COUNCIL ASSESSMENT REPORT

Panel Reference	PPSSNH-76
DA Number	2017/181/F
LGA	Willoughby City Council
Proposed Development	S4.55(2) modification seeking internal and external alterations to the approved mixed use building including lift access to the roof top level communal open space and modification to Condition 25 relating to number of adaptable units.
Street Address	989-1015 Pacific Highway, Roseville
Applicant/Owner	KECO City Developments Pty Ltd
Date of DA lodgement	2 March 2020
Number of Submissions	0
Recommendation	Approval
Regional Development Criteria (Schedule 7 of the SEPP (State and Regional Development) 2011	Capital Investment Value of original DA: >20 Million
List of all relevant s4.15(1)(a) matters	<i>SEPP(65) Design Quality of Residential Apartment Development and ADG SEPP(Basix) SEPP (Infrastructure) SREP (Sydney Harbour Catchment). SEPP 55 – Land Remediation Willoughby Local Environmental Plan 2012 Willoughby Development Control Plan 2016</i>

SNPP NO: PPSSNH-76
COUNCIL WILLOUGHBY CITY COUNCIL
ADDRESS: 989-1015 PACIFIC HIGHWAY, ROSEVILLE NSW 2069.
DA NO: DA-2017/181/F
PROPOSAL: S4.55(2) MODIFICATION SEEKING INTERNAL AND EXTERNAL ALTERATIONS TO THE APPROVED MIXED

Figure 1: Extract from Roof plan

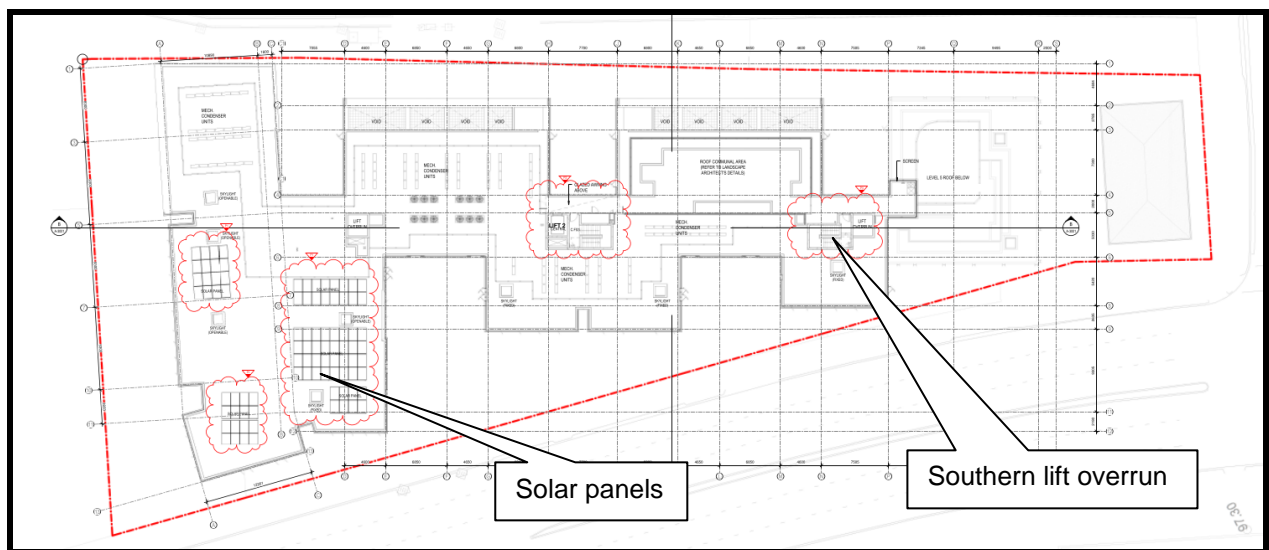
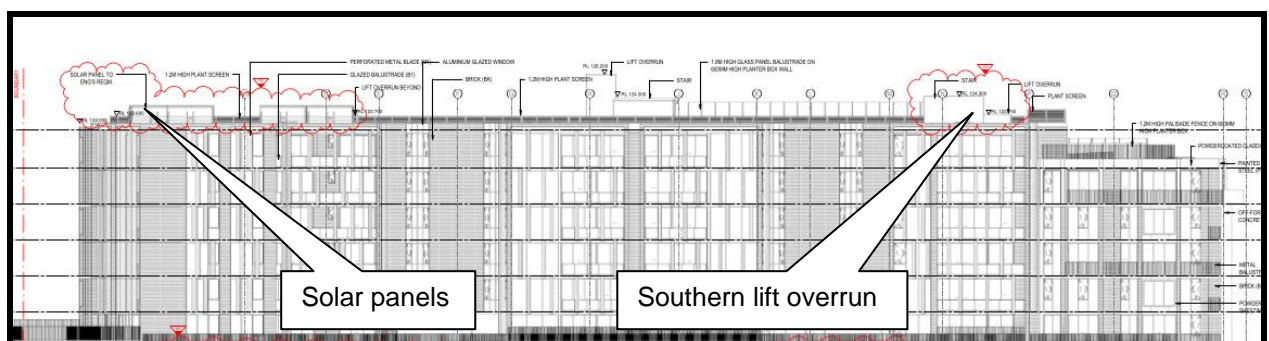
The current proposal includes two features which exceed the WLEP 2012 building height development standard of 20m:

- The proposed roof top solar panels will attain a height of 27.4m above existing ground level.
- The proposed southern lift overrun will attain a height of 27m above existing ground level.

The proposed roof top additions will attain a maximum height 1.6m-2.0m lower than the highest point of the approved building (central lift overrun). The solar panels will extend 0.9m above the nearby approved plant screen. The southern lift overrun will extend 0.5m above the nearby glass balustrade. The footprint of these additions will be relatively modest. The visual impact from street level will be minor and will not significantly affect the perceived bulk and scale of the overall building.

Given that the proposed roof top additions will attain a maximum height 1.6m-2.0m lower than the highest point of the approved building (central lift overrun), those additions are consistent with the transition in building scale represented by the existing approval.

Figure 3: Extract from approved DA-2017/181/C plans

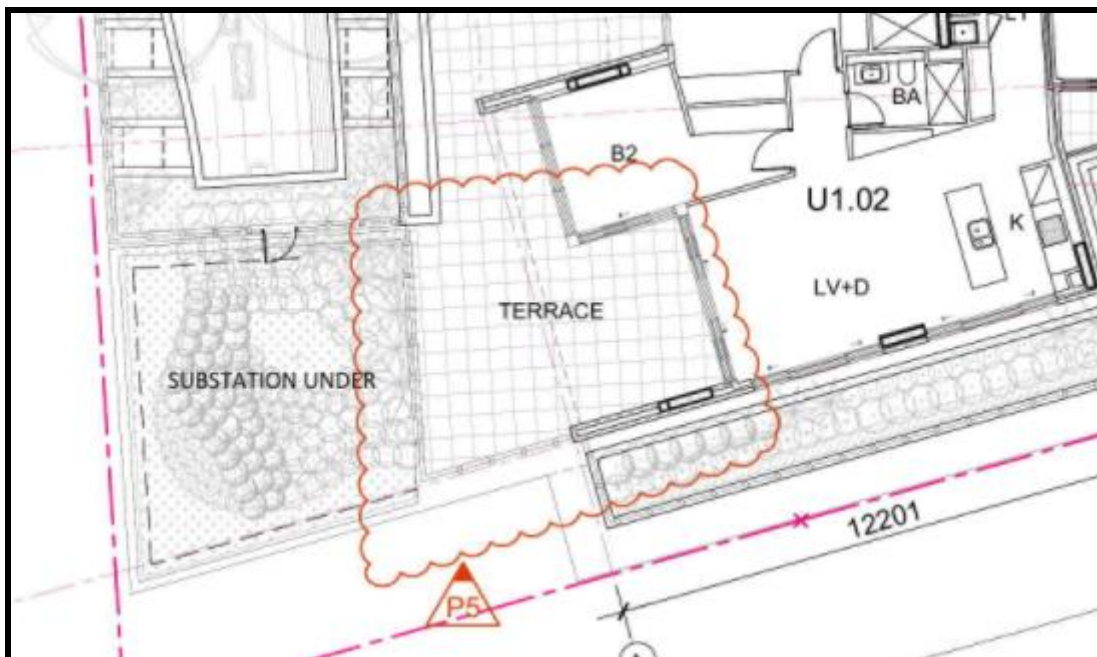
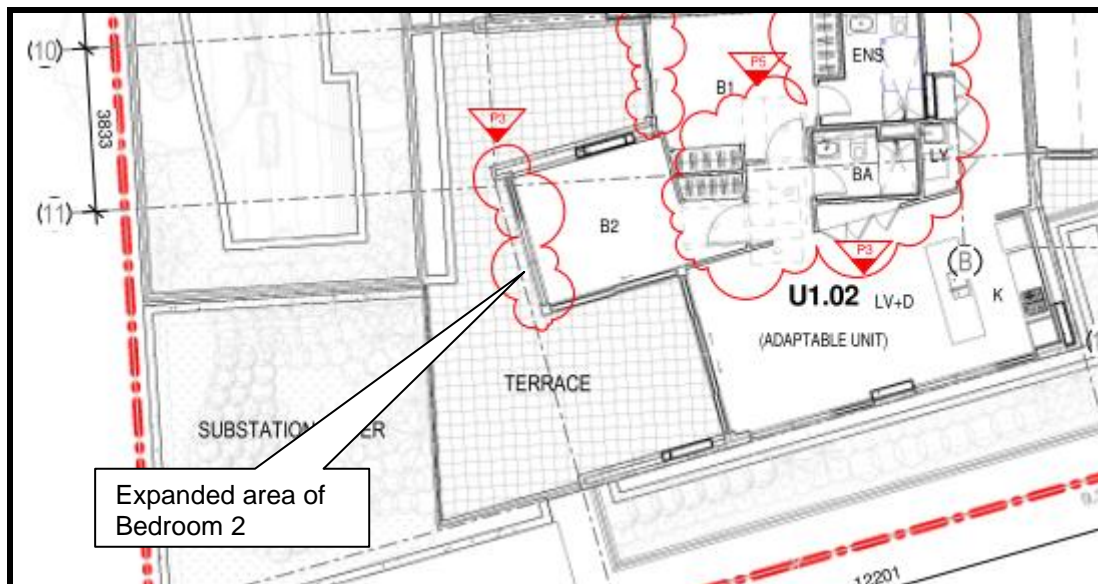
The proposed increase primarily results from redesign of units and use of previously empty risers. The only changes to the approved building envelope are a small increase to the areas of the northern bedrooms of Units 102, 202, 302, 402, 502 and 602, situated on the north-western corner of the approved building. The example of Unit 102 is indicated in the diagrams below. The first diagram shows the approved terrace and Bedroom 2 of Unit 102. The second diagram shows the proposed reduction of the terrace area and corresponding increase of Bedroom 2.

The northern wall of Bedroom 2 is to be stepped out by approximately 0.8m. Bedroom 2 will therefore increase in size by approximately 2.6m². This increase of Unit 102 will be repeated across Units 202, 302, 402, 502 and 602. The total GFA increase will therefore be 15.6m². This will all take place within the broader approved building envelope.
